# Expert Review of Drayton South Open Cut Coal Project

NSW Department of Planning and Infrastructure

Report No: ADV-SY-04075

Date: July 2013

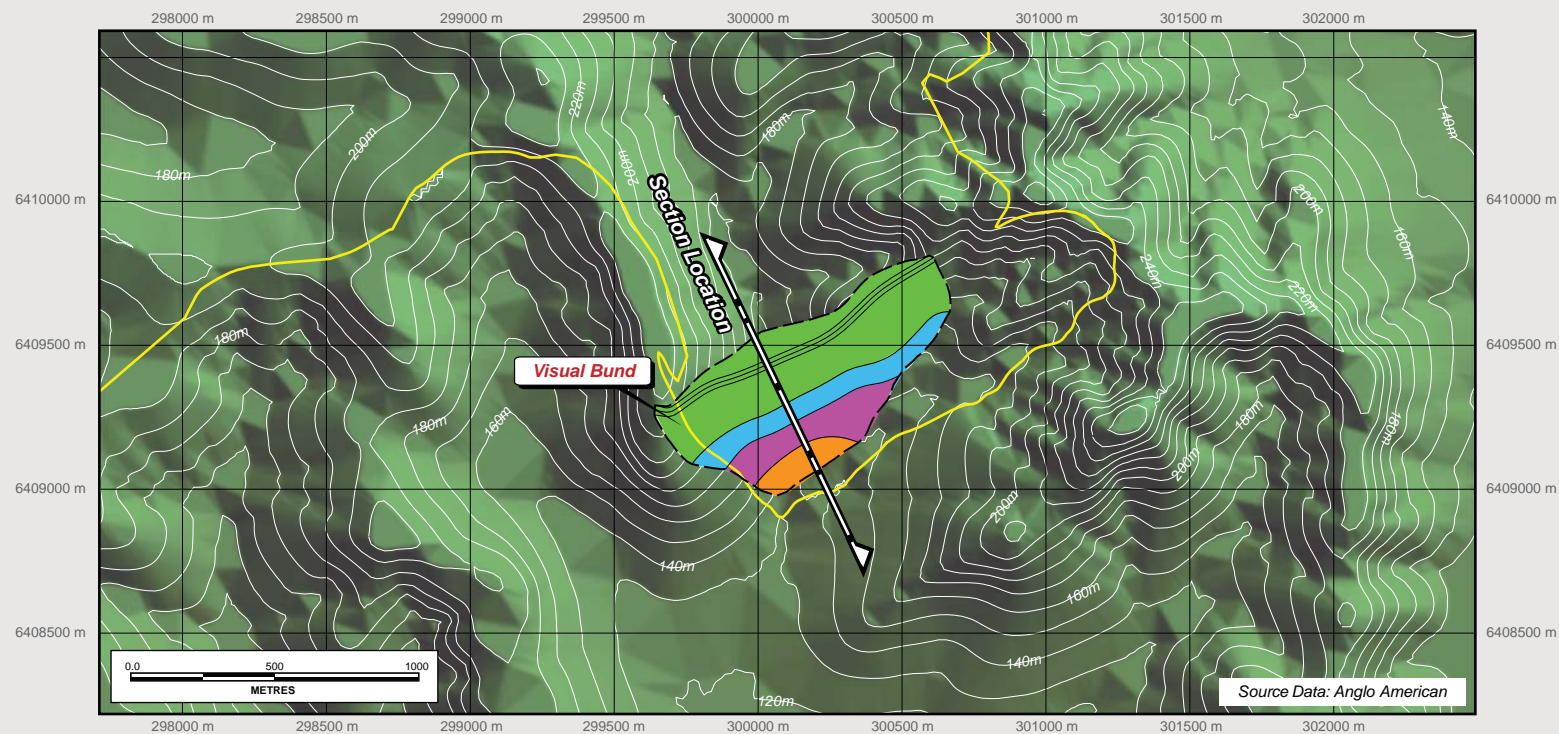
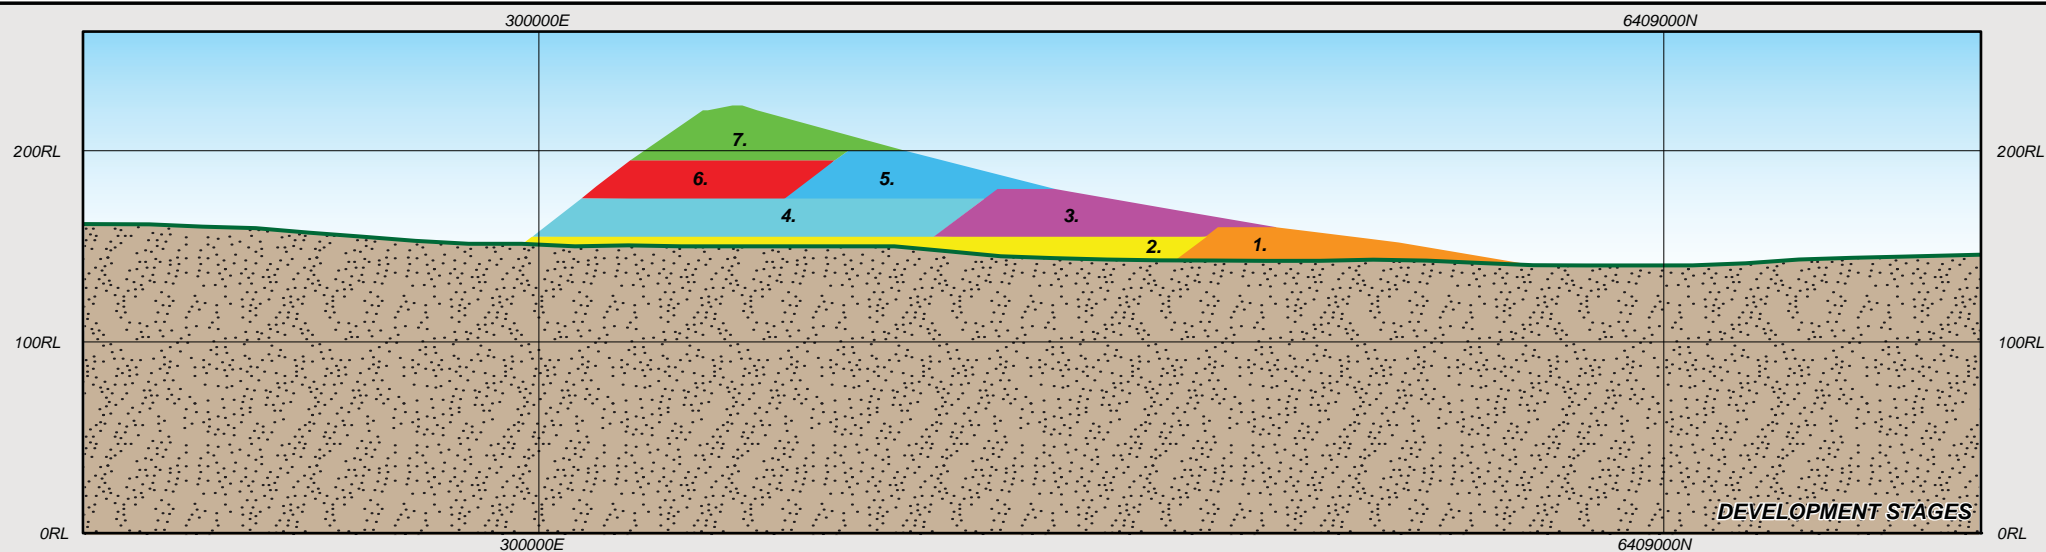
**Figure 3.1** shows a cross section through the Option 4 visual bund. Anglo plan to construct the bund during both daytime and nighttime operations with the exception of the initial lift. Restricting the construction of the visual bund to daytime operations would increase the build time by 7 months.

- There are three potential options for the construction of the Visual Bund;
  - Day and Night operation, within noise and air quality guidelines – 8 month construction
  - Day and Night operation, allow noise and air quality exceedances (night time operation only on the initial dump lift is predicted to exceed criteria) – 7.5 months
  - Daytime only operation, within noise and air quality guidelines – 15 months
- Restricting construction to daylight hours will increase the build time by 7 months
- Allowing noise and air quality exceedances only reduces the build time by 0.5 months as it only impact on the initial lift of the bund.
- Build times validated by RPM

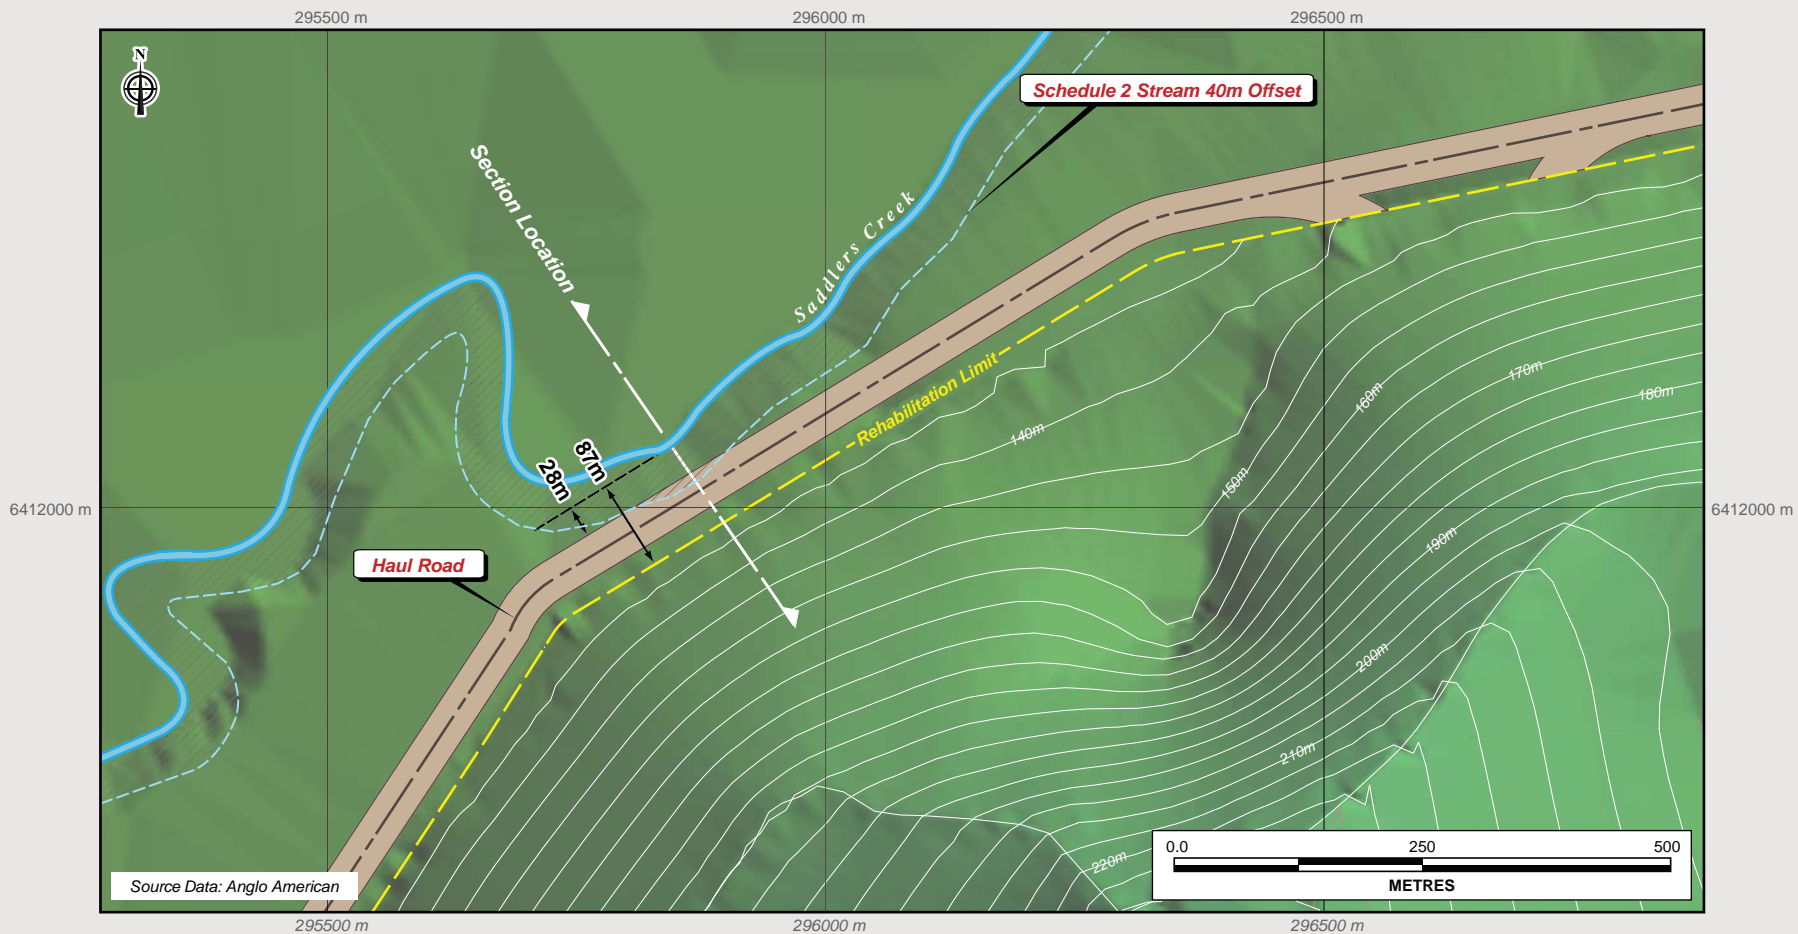
It is feasible to reduce the size of the central ramp through periodic re-grading at a steeper grade.

- The current ramp follows the coal floor at 2-3% grade.
- Options exist for reducing the size of the central ramp such as:
  - Periodic re-grading the central ramp to 10% with parting to the pit exit level of RL145m
- This would allow the crest of the central ramp void to close up, reducing the size of the void due to the ramp.
  - EA final central ramp volume is 38Mcu.m
  - Re-grading reduces final ramp void to 11Mcu.m
- A swell factor of 1.3 has been used in the EA dump and final landform planning. Anglo expect that this may be a conservative assumption and that actual compacted swell factors may be lower. A downward revision of the swell factor may enable additional material to be stacked adjacent to the crest of the ramp and below the line of visual impact. This material could be pushed into the ramp at the completion of mining to reduce the size of the void

**Figure 3.2** shows plan and section views of the 10% re-graded central ramp.

**EA FINAL LANDFORM**

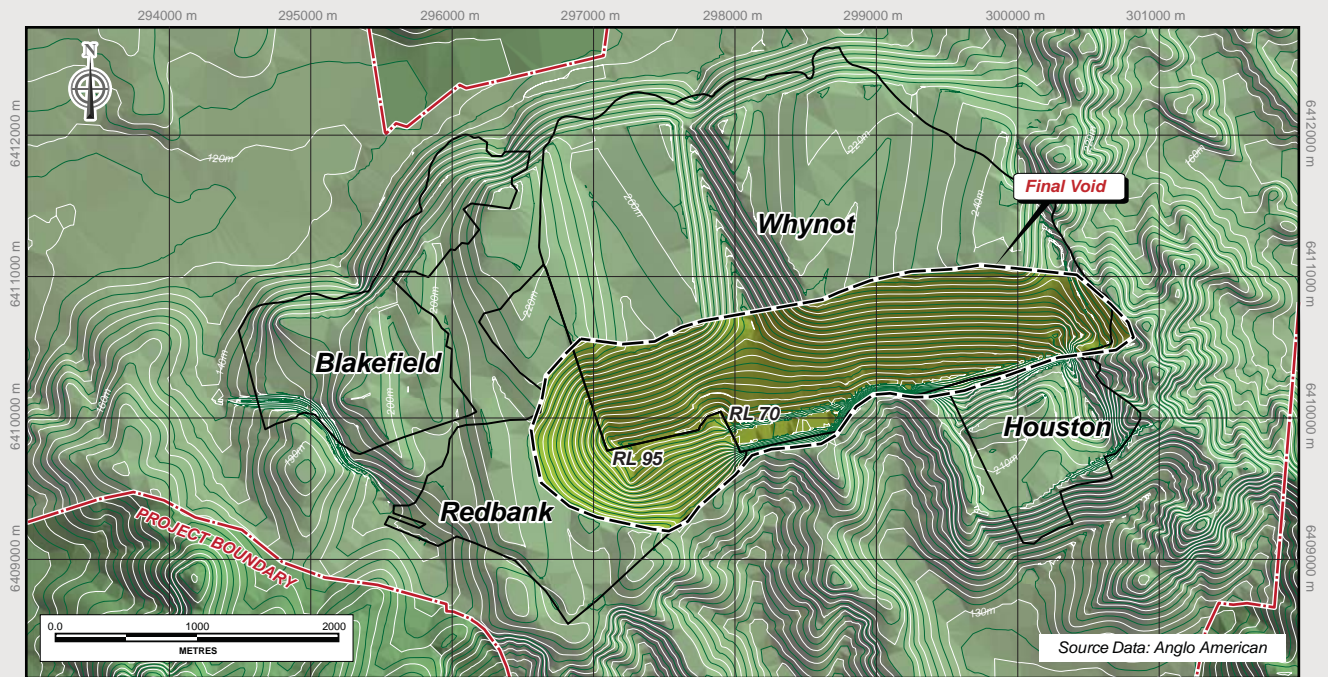
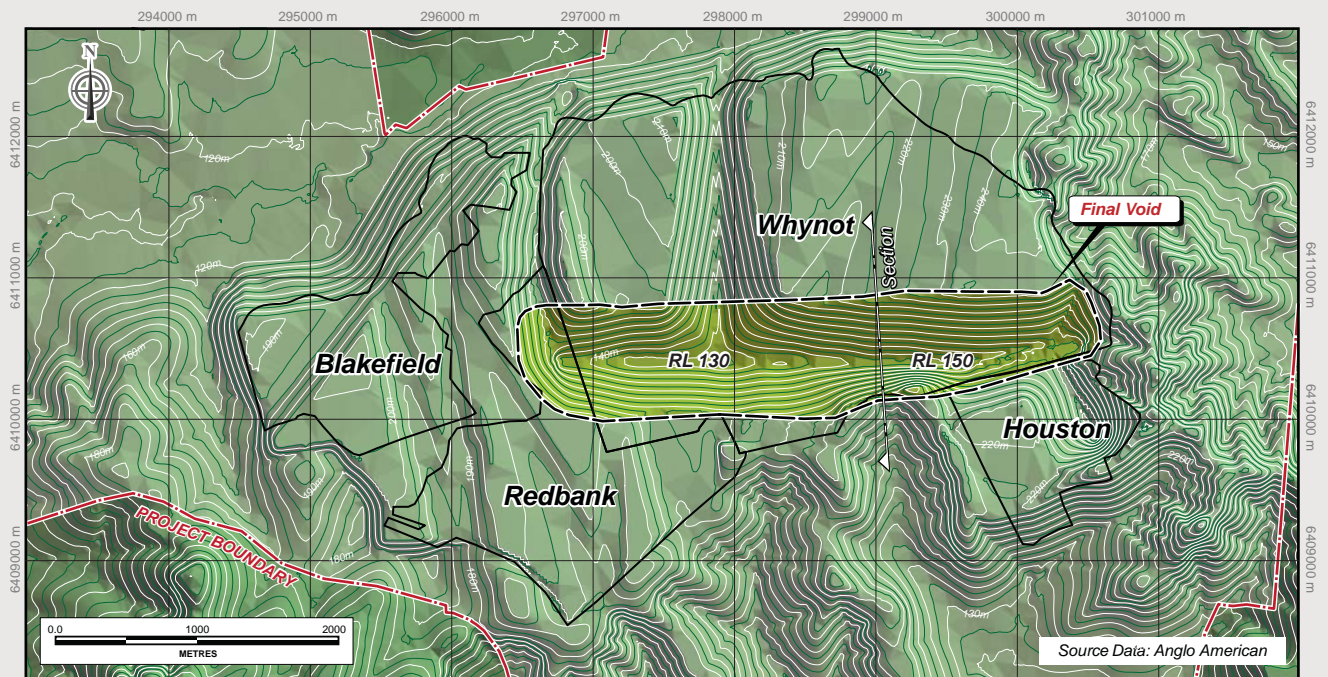
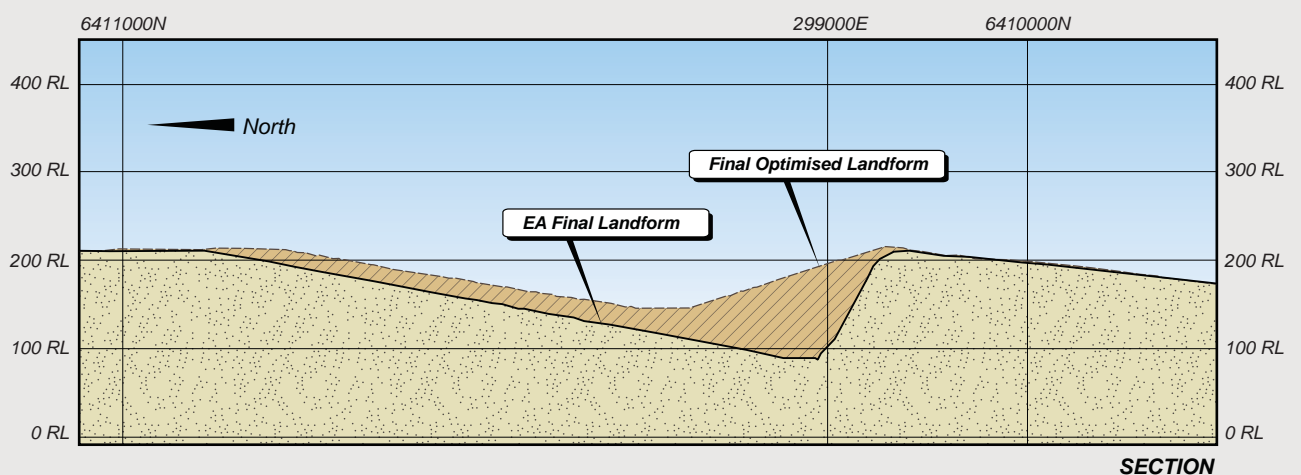
Anglo has developed a draft concept that has a material reduction of the final void at Drayton South.

- Anglo are currently assessing an option to reduce the size of the final.
- The option involves mining the pre-strip of the Whynot Pit from the south, placing the truck and shovel spoil on top of the insitu dragline system as this sterilises approximately 2.5Mt of ROM coal that would have been mined by the dragline. This would have immaterial impact to project economics.
- Advantages are that the dragline bench can be blasted down and the truck and shovel spoil can be dozed down to 10 degrees at completion of mining

- This in conjunction with a reduced central ramp should have a material impact on the size of the final void and final landform
- Measuring the final void between the original topo and the final landform the EA void measures 220M cu.m compared to 95M cu.m for the revised landform. This is substantial reduction.
- This would have no impact on the overall disturbed area footprint of the project

A preliminary draft of the revised final landform has been generated by Anglo and presented in **Figure 3.4**.
